Northpoint Commerce Center

DR23-007

January 18, 2024

Proposed Landscape Plan

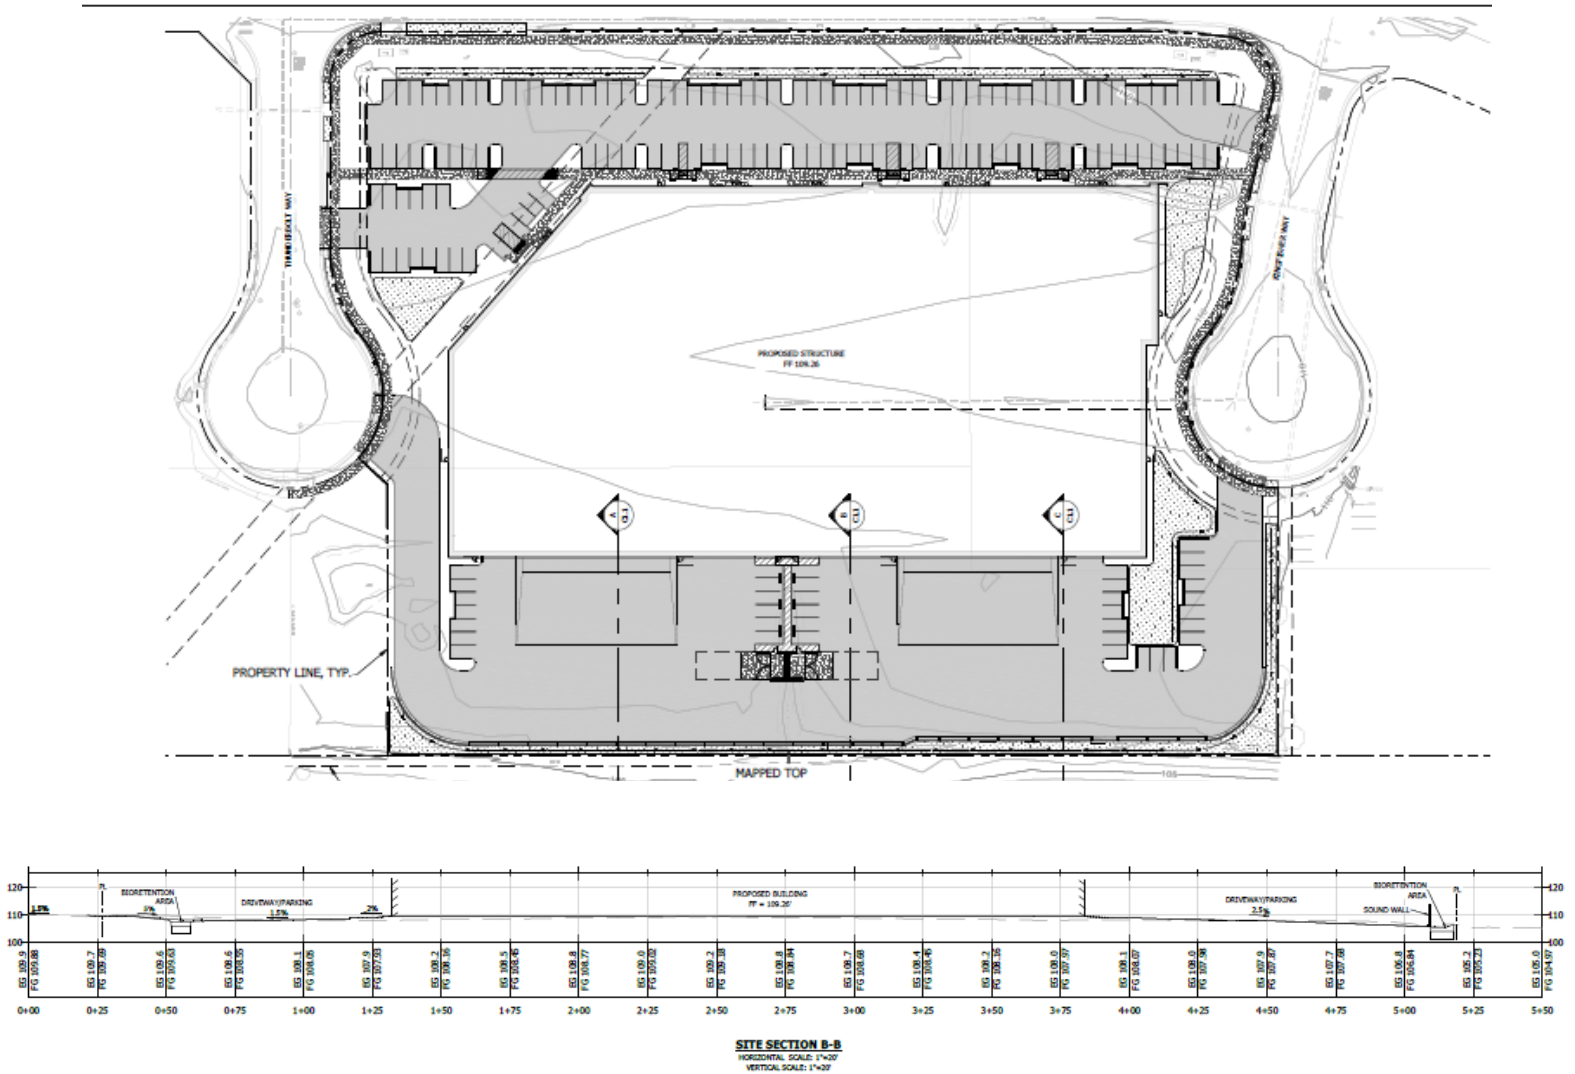
- The proposed color, form and massing of the building are appreciated.
- Provide a more detailed landscape plan; more robust planting at the south property line that is adjacent to the creek is recommended.
- The site layout and building orientation are appreciated.
- Consider proposing additional materials around the entrances and/or corners of the building.

- Consider removing the sound wall, located along at the south property line, to provide more transparency between the site and the creek.
